ADDENDUM # 1

DATE: April 11, 2025

**FOR: PCDL – NEW LEXINGTON
ADDITION & RENOVATION**

UPPER LEVEL POWER PLAN

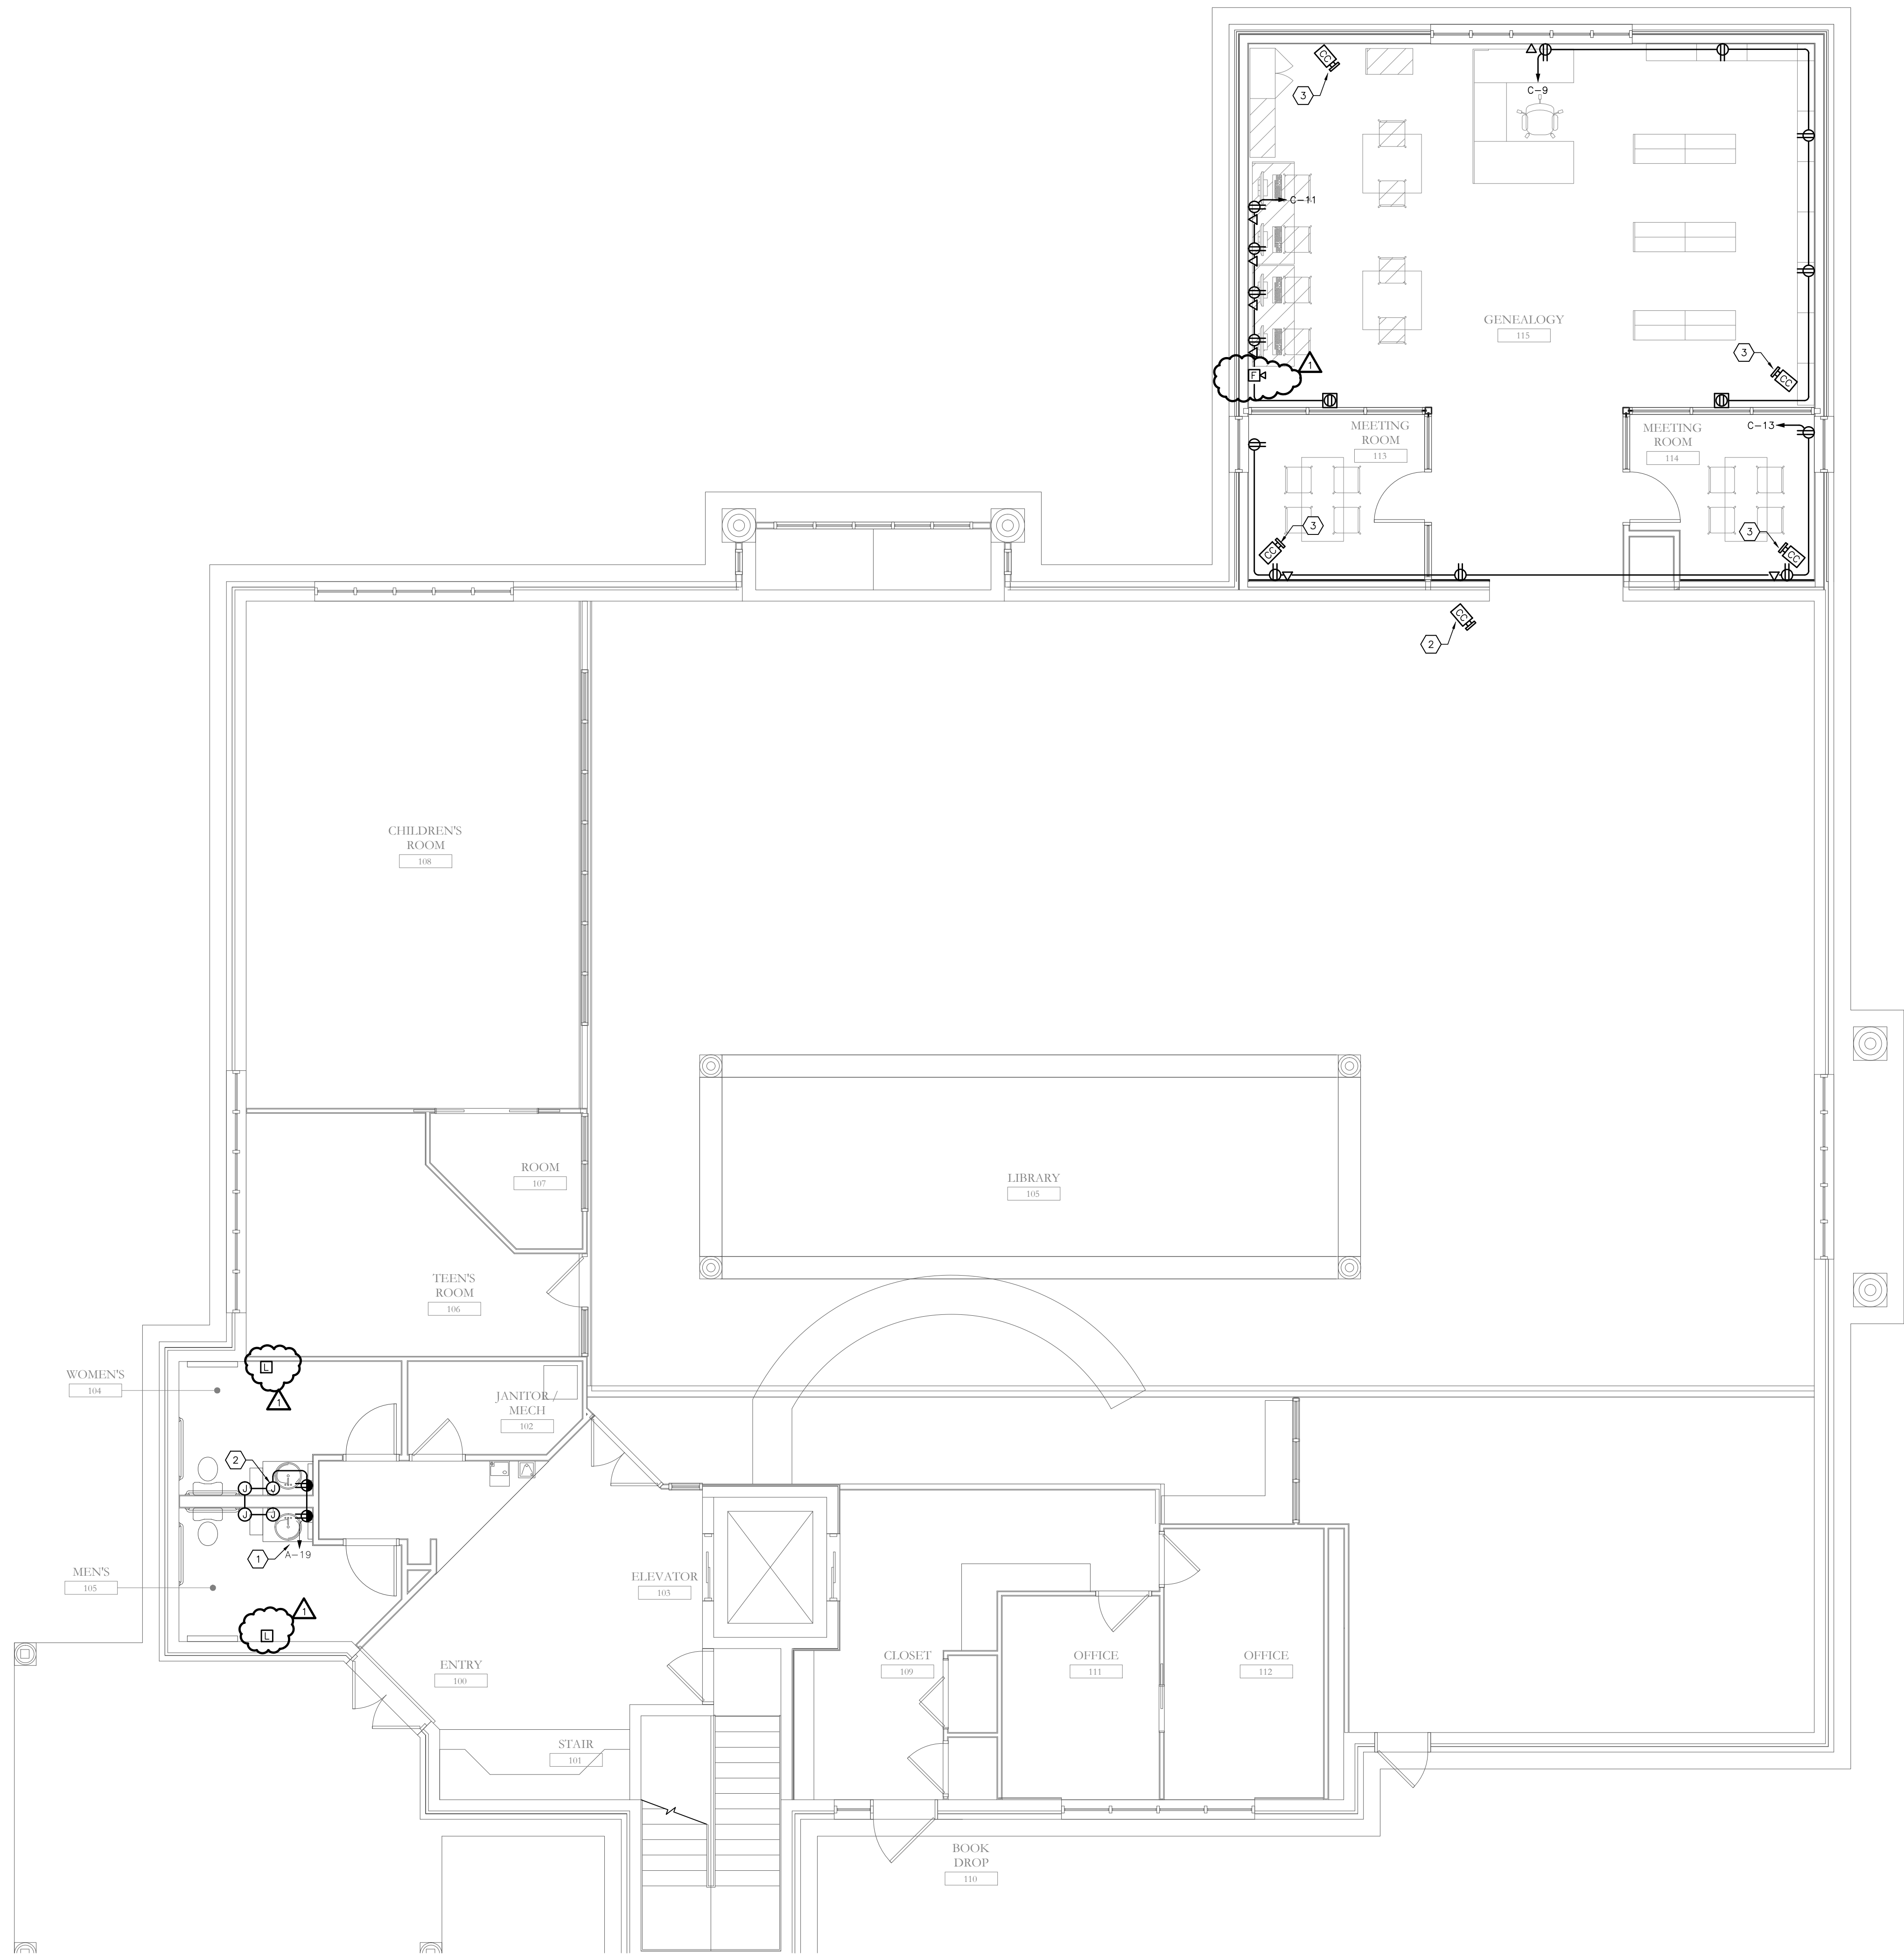
Item #3 Upper-Level Power Plan – replace E-202 with attached

- a. Added additional new fire devices to restrooms and genealogy room
